16 March 2026

Hon Paul Scully MP  
Minister for Planning and Public Spaces  
Via the NSW Planning Portal

**Objection to SSD 975288708 – Mixed Use Development 160 Oxford Street, 142-148, 13 Gibbs Street and 6 Shadforth Street, Paddington**

London Plane Trees T2-T5 in winter (Appendix 1 - Tree Data Schedule)

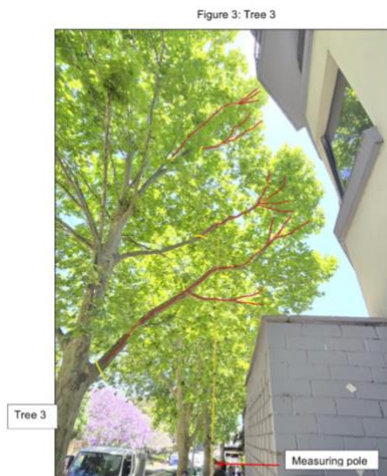
These deciduous trees will, however, lose their leaves in winter and provide little to no visual screening during the winter months. The true perception of the building from the public domain and adjoining properties in the winter time will be very different from the images provided.

This is a critical omission and a proper visual impact assessment must show summer and winter views - with and without foliage. By relying solely on the summer imagery, the unacceptable impacts are significantly understated.

By using the summer foliage to mask the true scale and dominance of the new development, the Proponent underplays the extent to which the building will alter the streetscape. Suggesting the impacts are minor when in the winter time the building will be starkly more visible, is misleading.

The Tree Schedule in Appendix 1 of the AIS (extracted below) provides photographs of the street trees in winter - providing a very different perspective to the lush green canopy contained in the VIA imagery.

The Proposal should be assessed without assuming full and permanent tree screening. In addition, further analysis and data should be obtained to assess the likelihood that the trees can be maintained at their current size and form over the life of the development. Data should also be obtained from Council to obtain a recorded history of the trees, their ongoing maintenance and estimated lifespan.

**Vehicles parking on Glenmore Rd footpath**

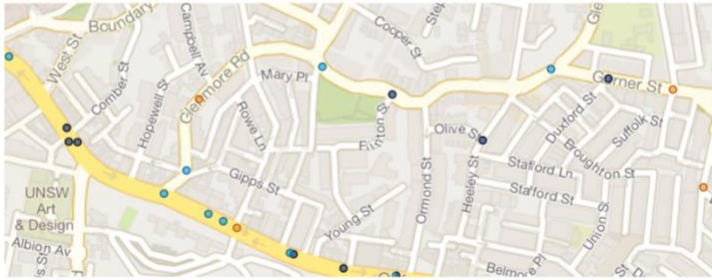
In addition, Glenmore Road is subject to a load limit for heavy vehicles of 3 tonnes and above. It is also a 'high pedestrian activity' zone and signposted accordingly. Parking has been removed from some areas of Glenmore Road to allow for the safe passage of vehicles. Cars regularly park on the footpath along Glenmore Road to avoid being side swiped or sustaining damage to side mirrors.

Figure 3A Heavy Vehicle Route Map

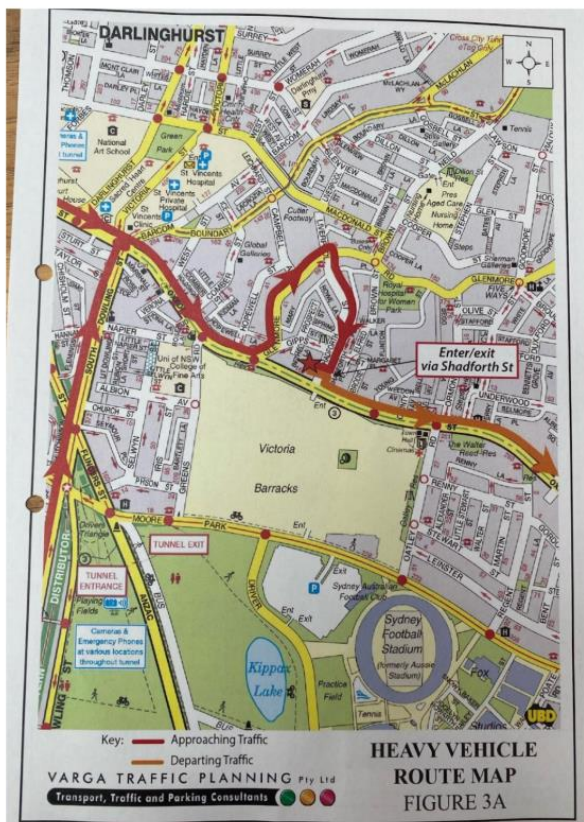
Despite this local information and accident data, the CTMP fails to identify these specific road network limitations and curiously concludes that:

'Light traffic roads and those subject to load or height limits will be avoided'.

The Proponent's Heavy Vehicle Route Map, however, directs heavy vehicles along Glenmore Rd, via Liverpool St and onto the intersection of Shadforth and Gipps Street. This is totally misconceived and unacceptable.

A revised CTMP is necessary to ensure that construction traffic and parking impacts are genuinely mitigated and are not unfairly imposed on local residents or the business community.
